Addendum

New Glasgow Public Library & PARL Headquarters Revitalization

| 16 April 2024 | 23-053         | 04         |

**MSK05**

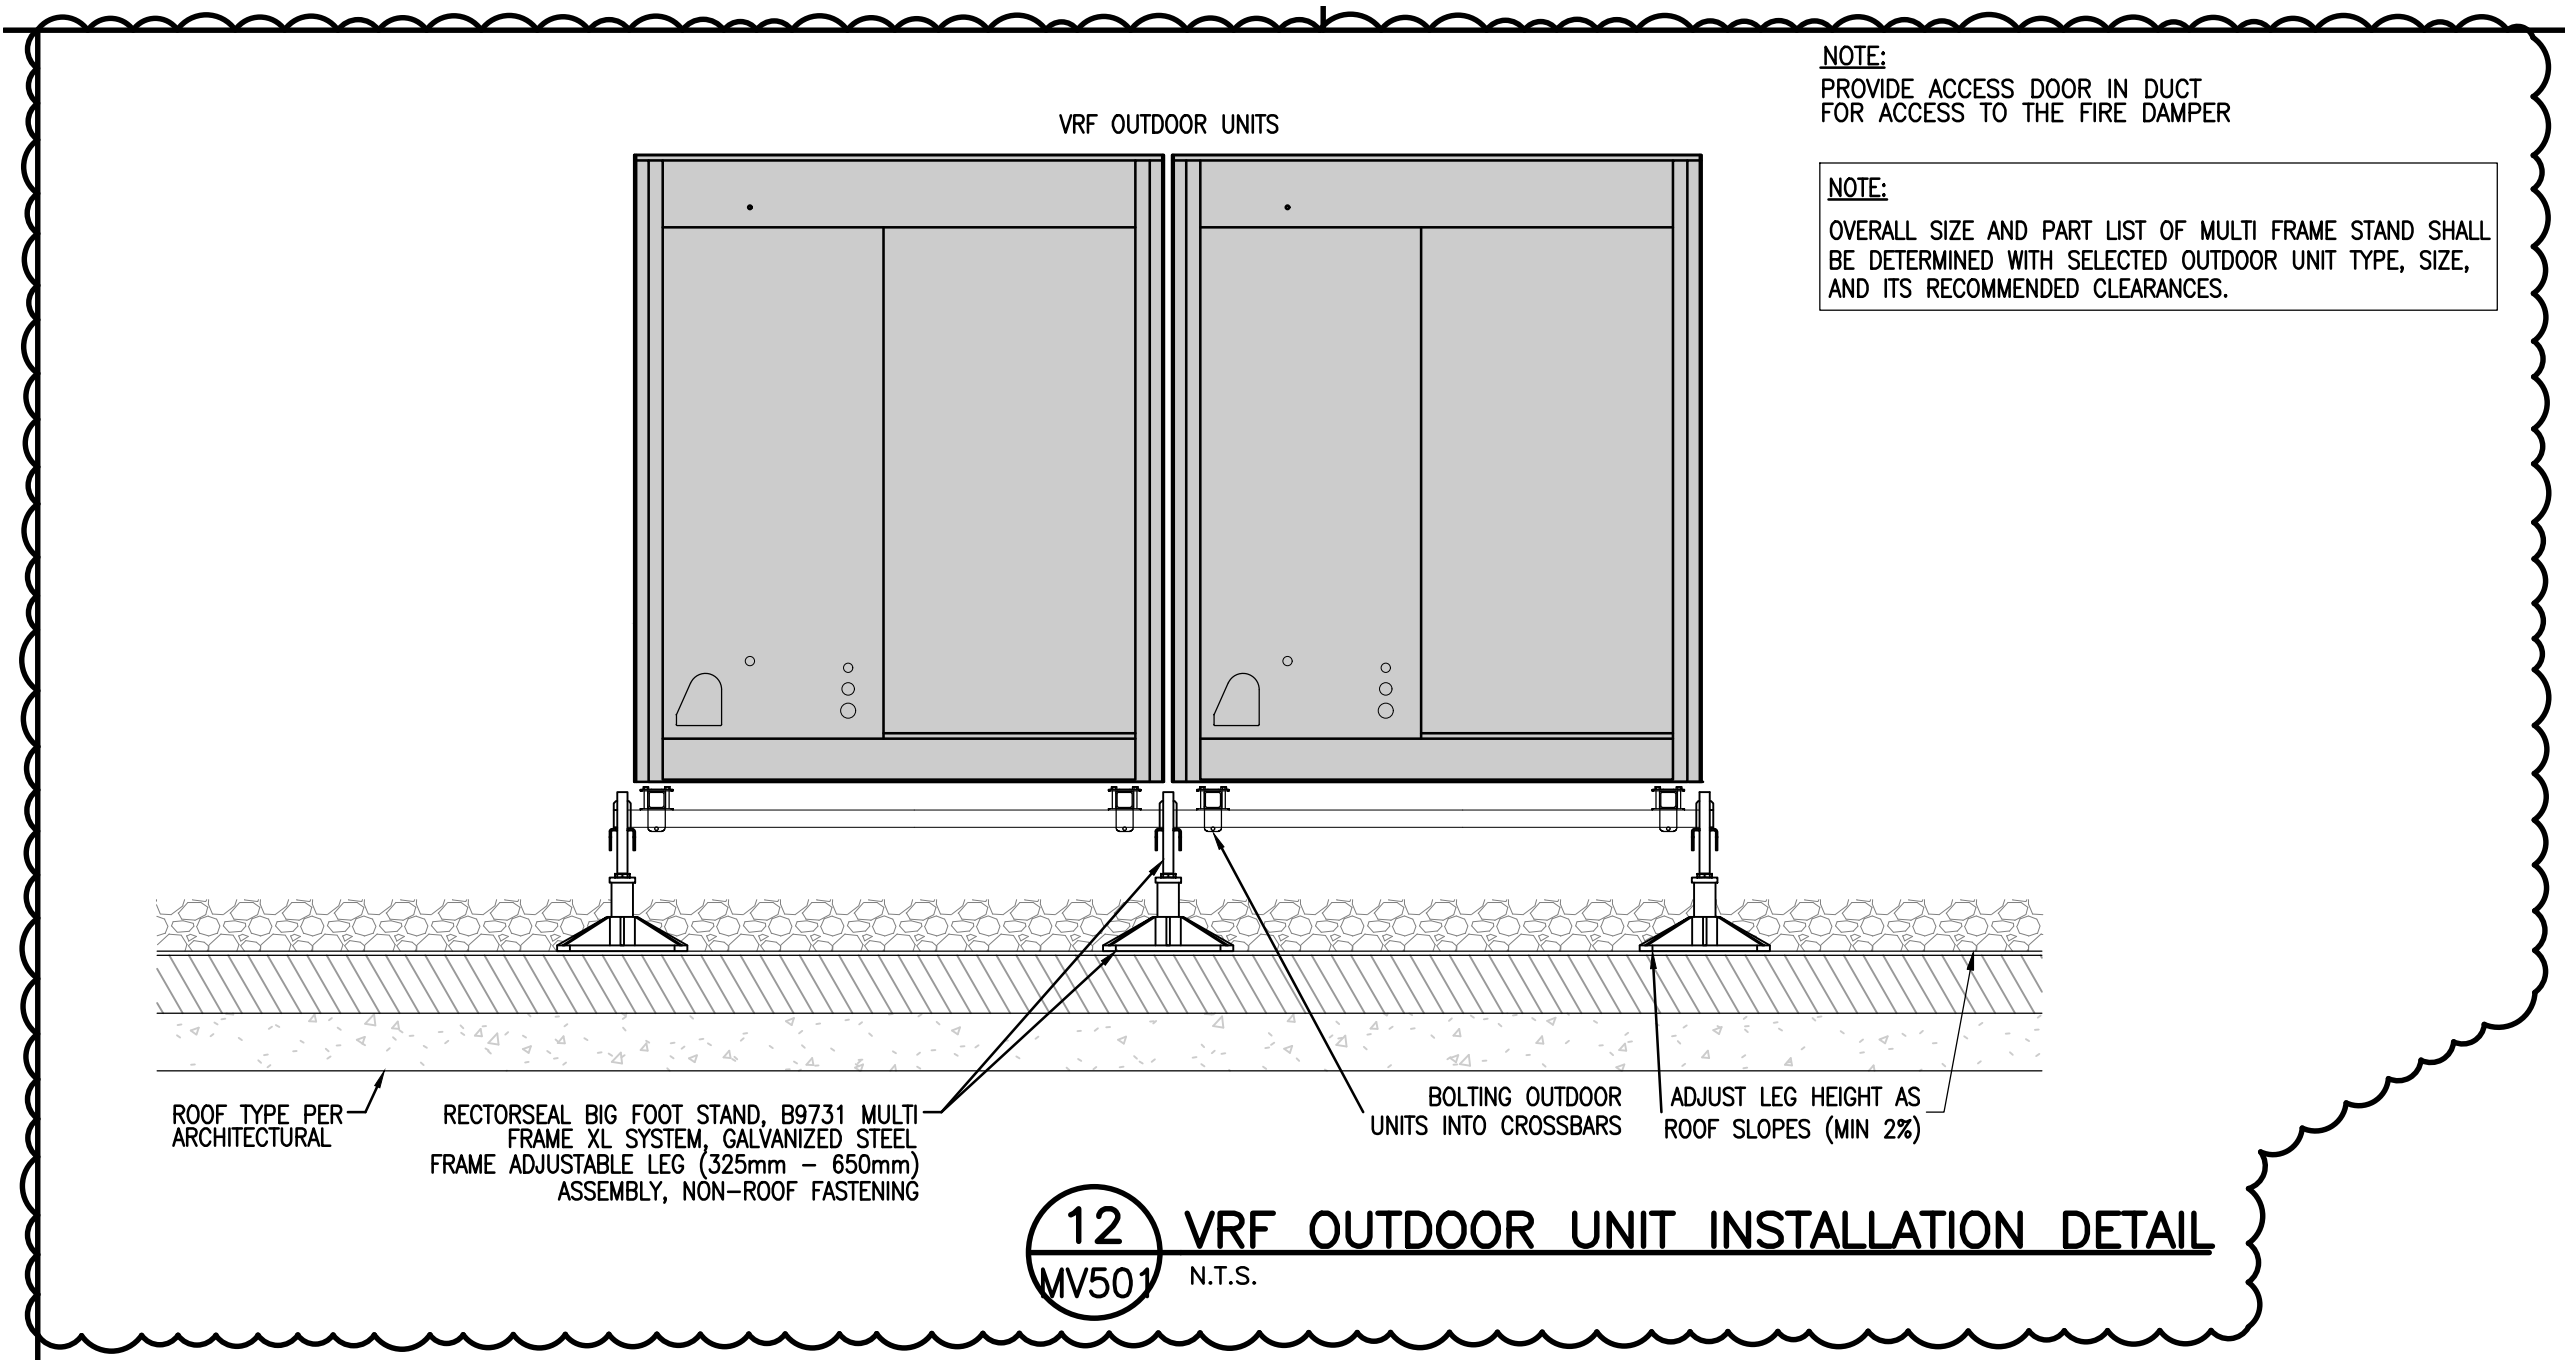
1. Revise with MSK02.
2. Revise with MSK03.
3. Add detail 2 as per MSK05.

MSK06

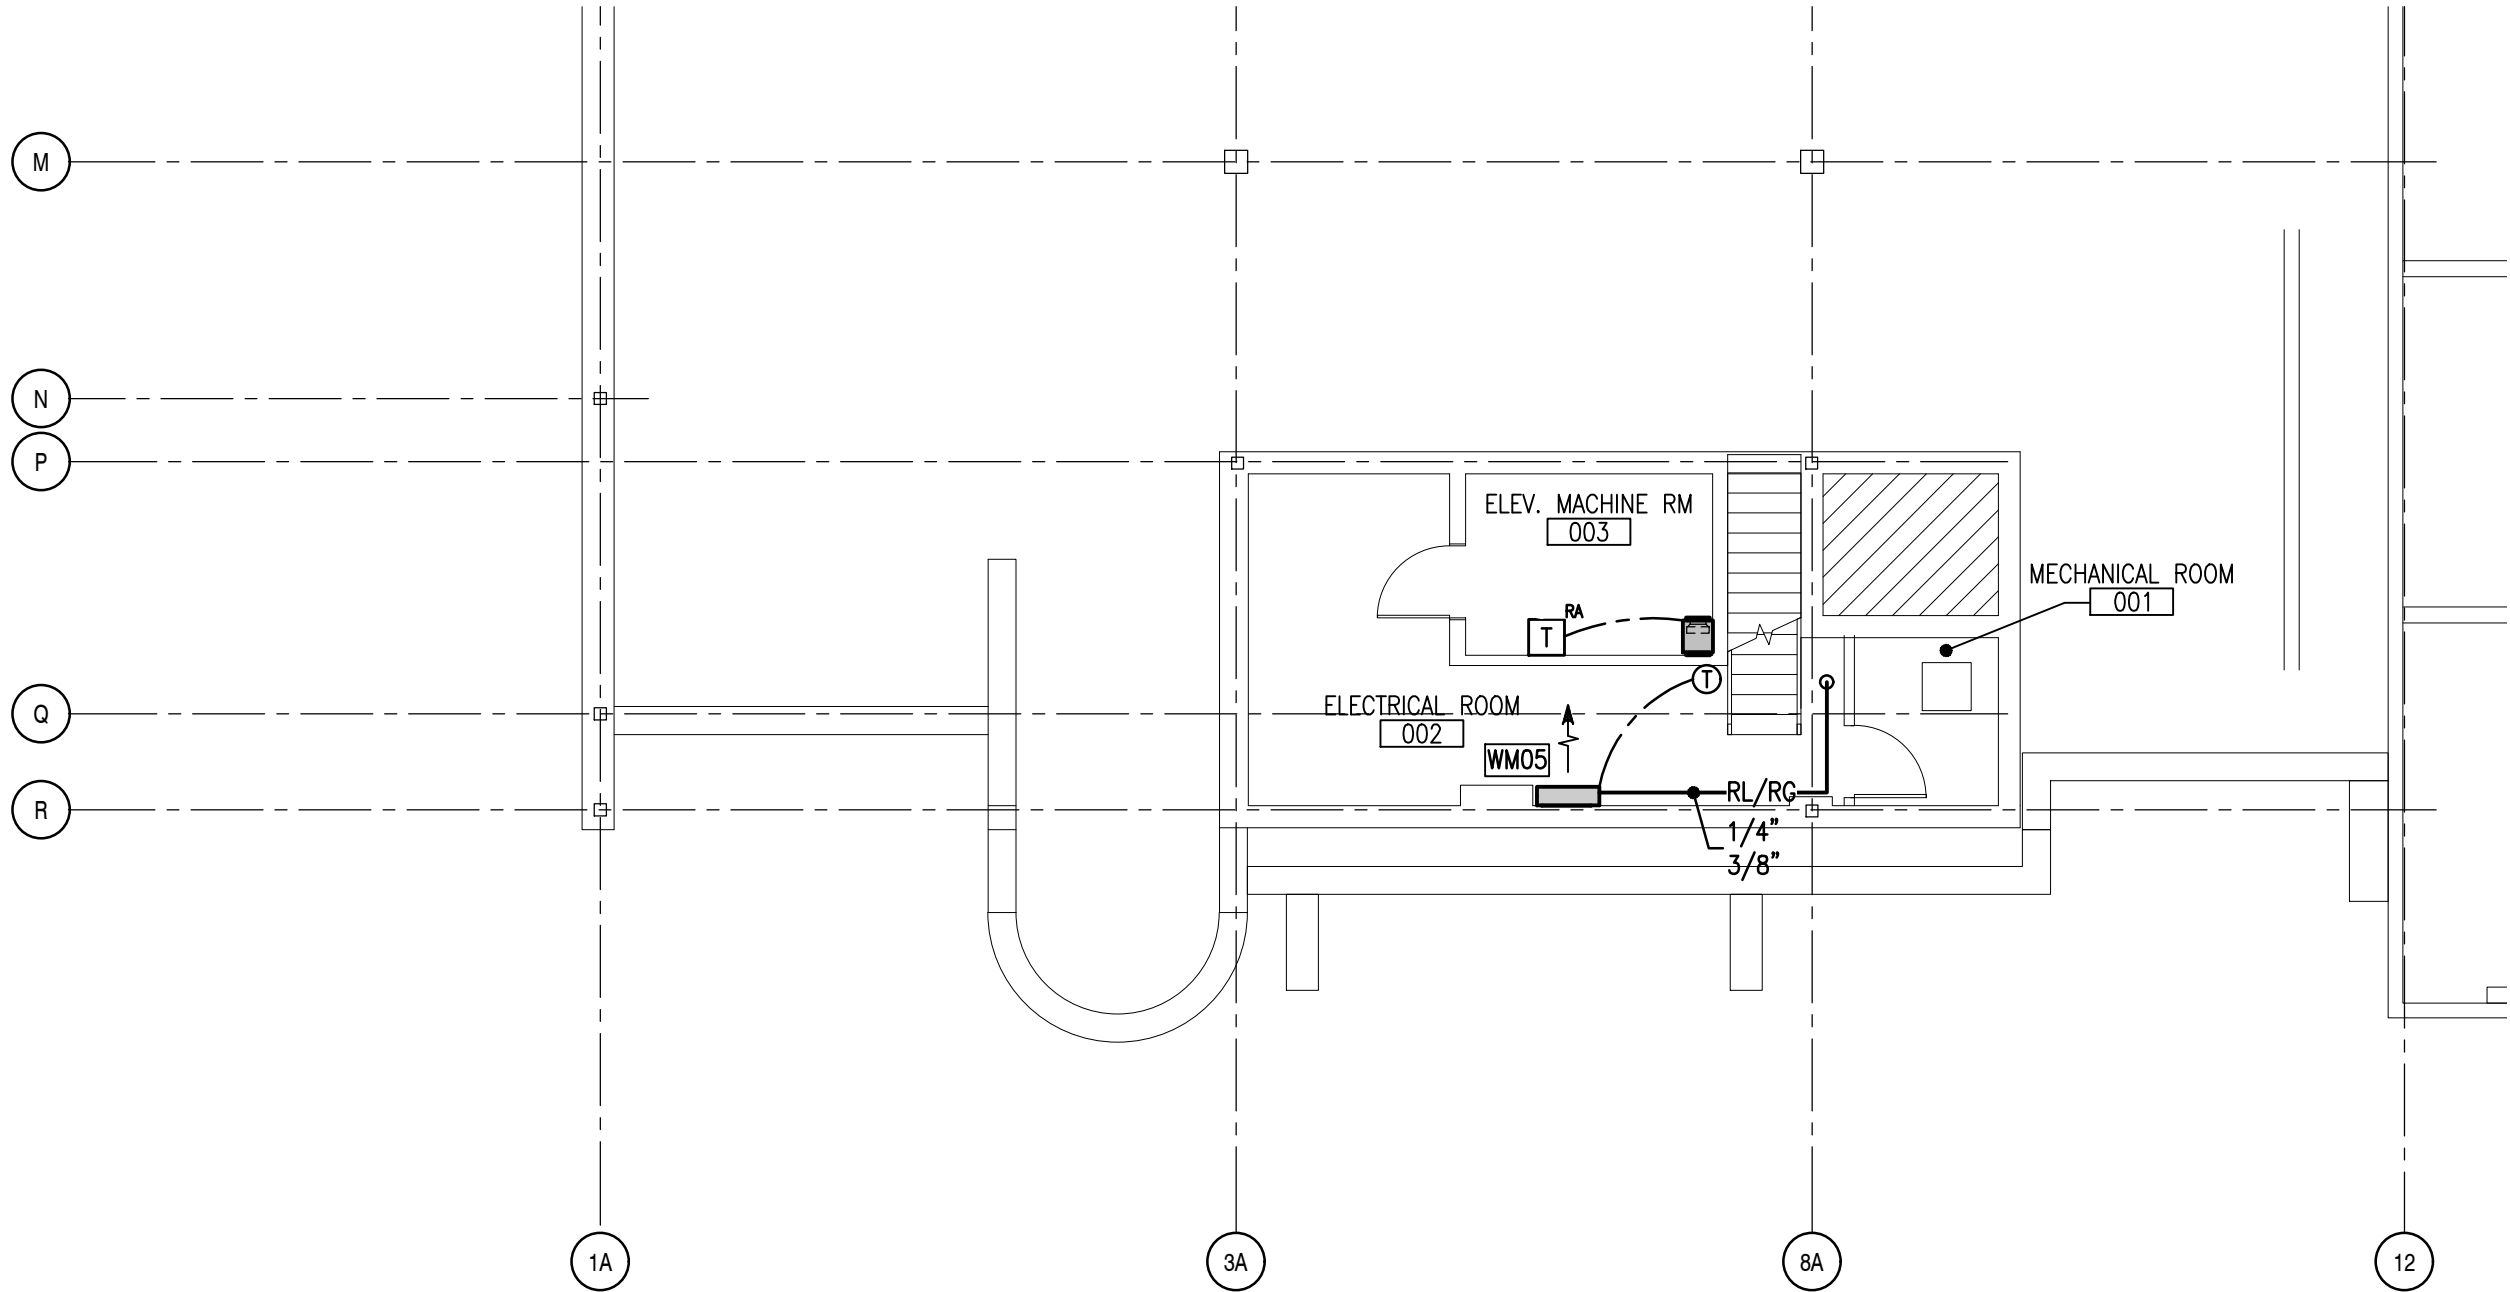
**2.11 Reference Drawing MV-104 Ventilation – Level 1 – New Work:** Add detail 2 as per MSK06.

**MSK07**

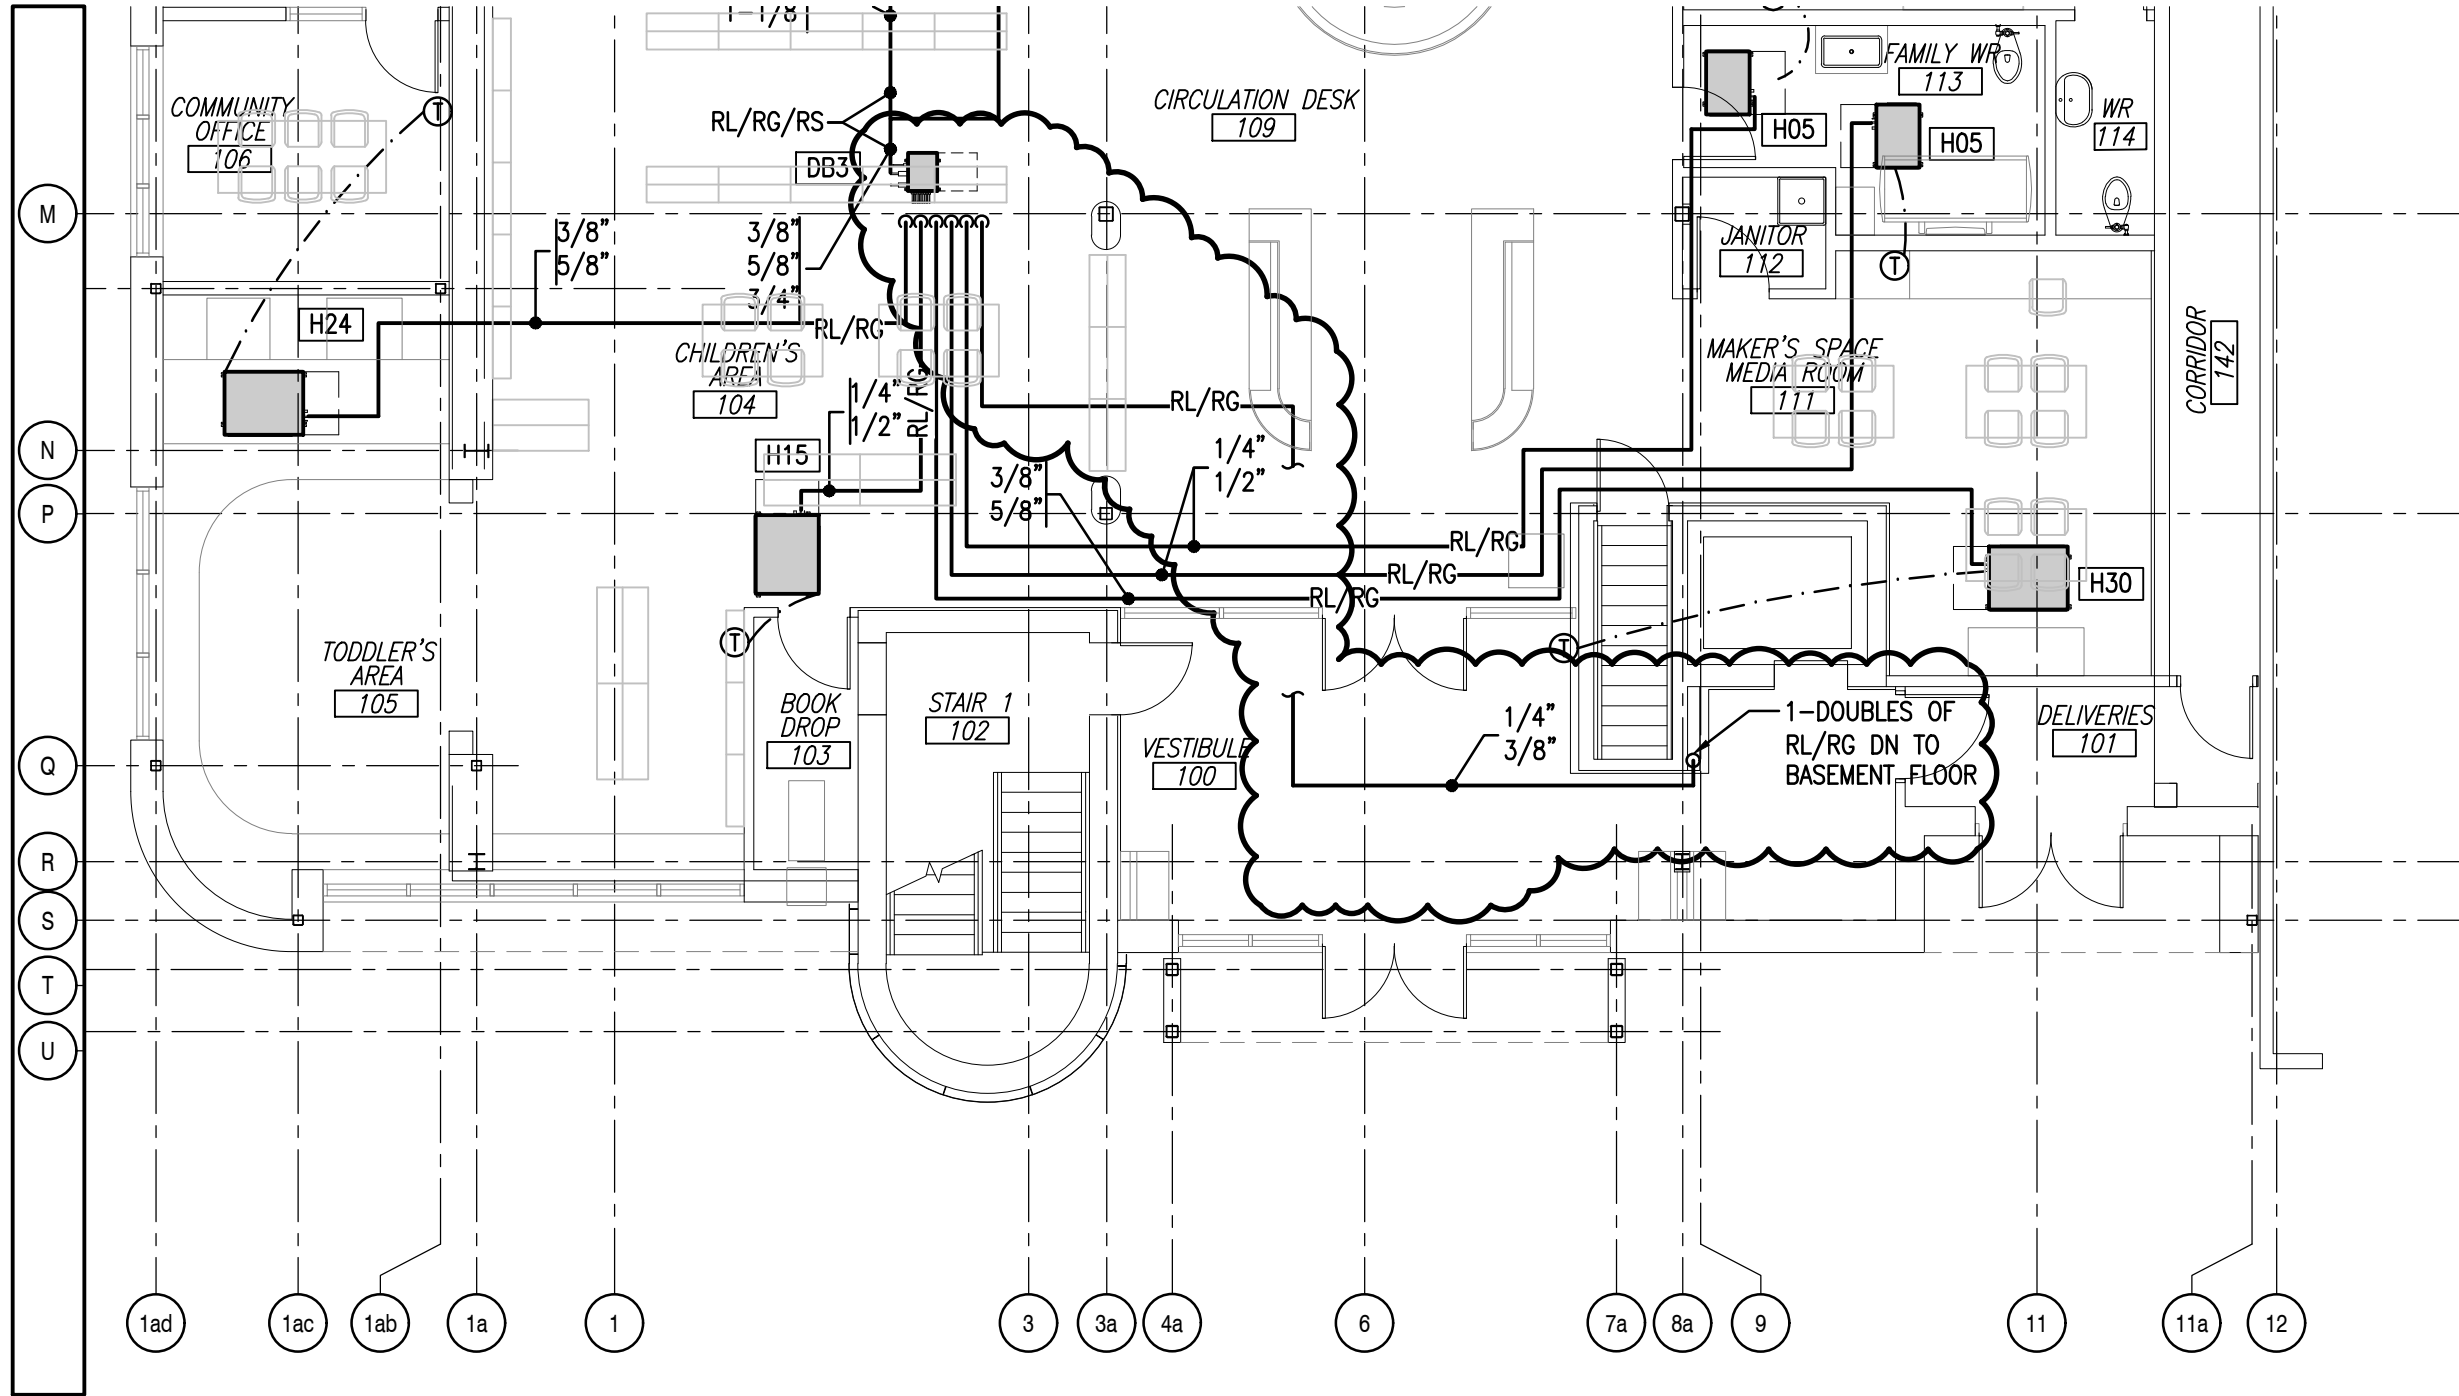
**2.12 Reference Drawing MP-104 Plumbing – Basement & Level 1 – Sanitary – New Work:** Add detail 2 as per MSK07.
